CHANGE ORDER APPROVAL FORM

PROJECT: Crawford Road Phase II

CHANGE ORDER NUMBER: 3

CONTRACT NUMBER: CM2935

FINAL SUBSOIL WITH TEMPLATE
SHEET 1 OF 1 051121134124

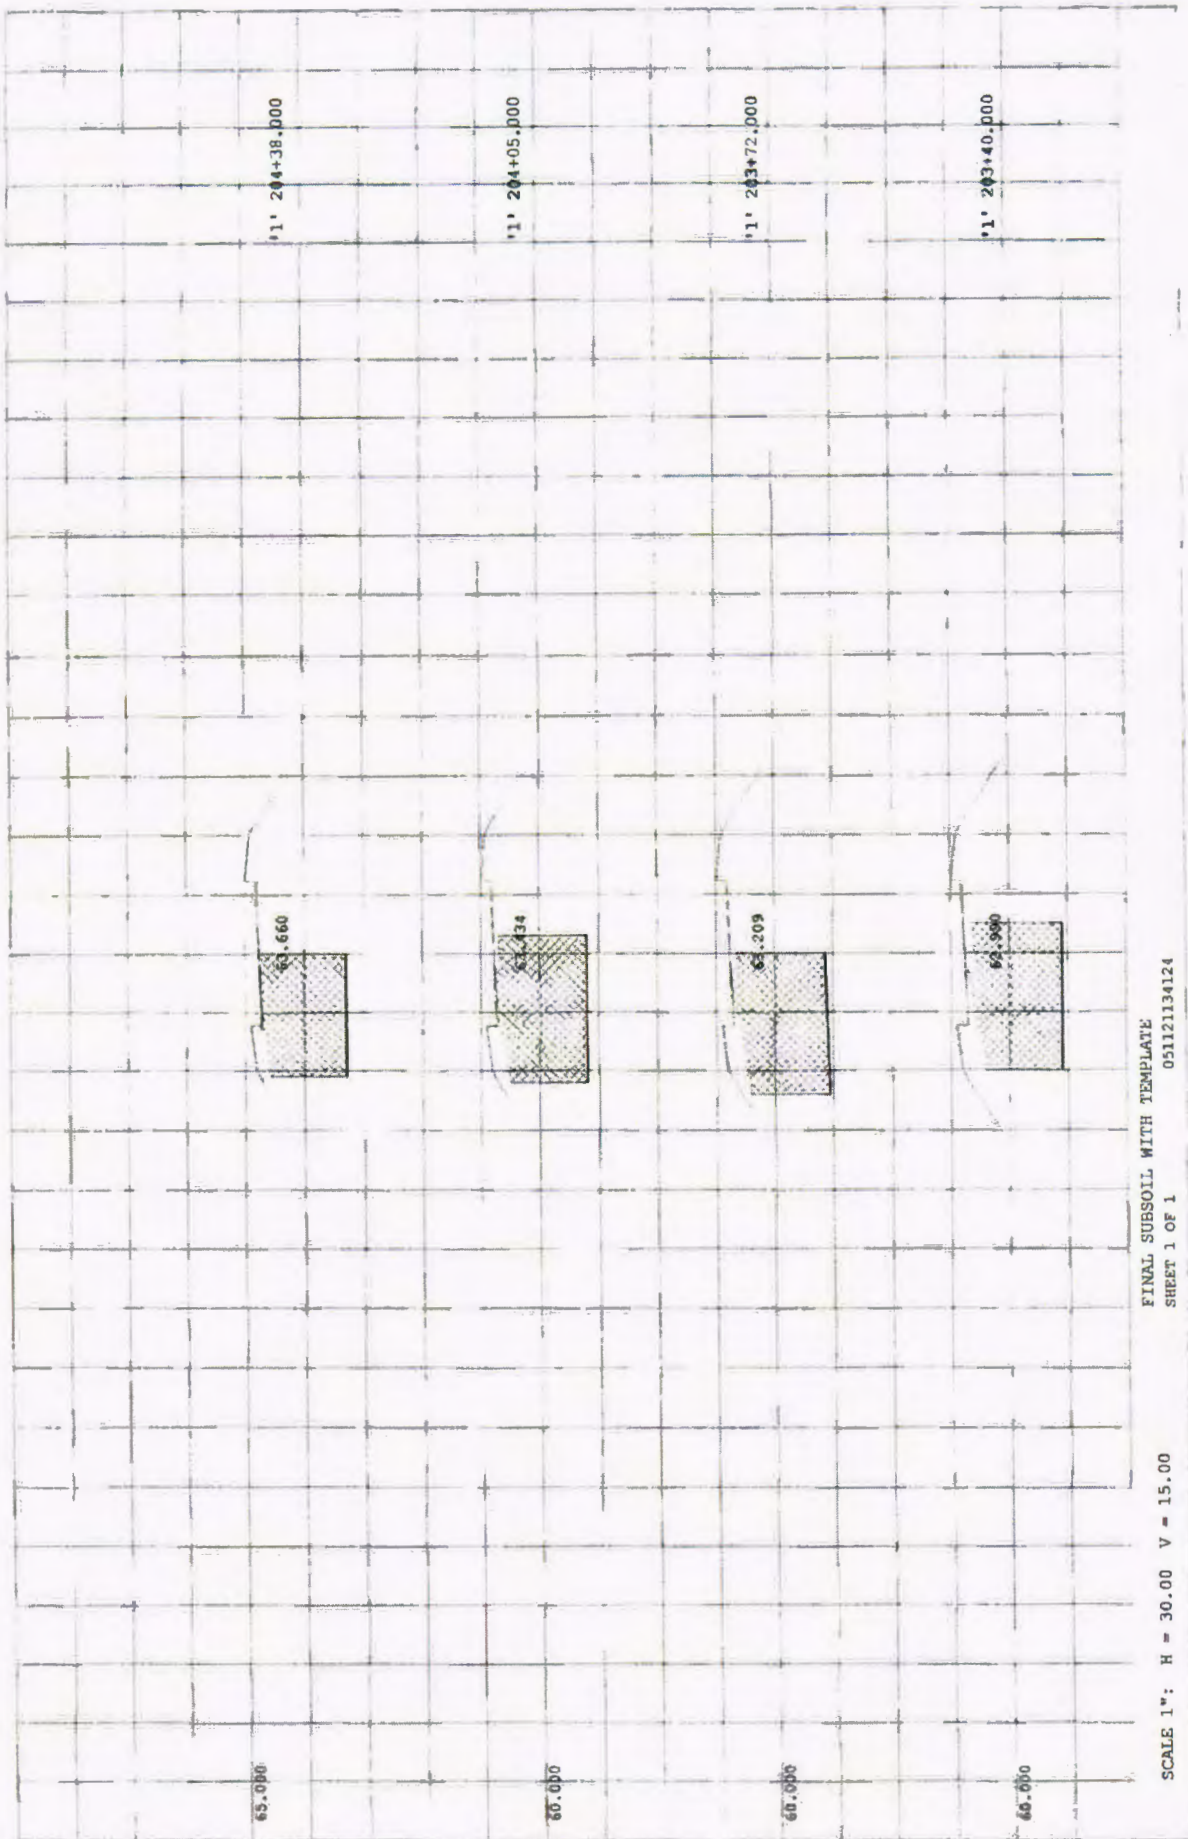
Reason for Change Order: Adjust contract time for days the contractor could not work (due to weather (rain), affecting the project site and the contractor's ability to work). Add 543.551 CY of Subsoil Excavation.

Demuck Area

643.551
- 100,000 cc No. 2

543.551 cc for cc No. 3
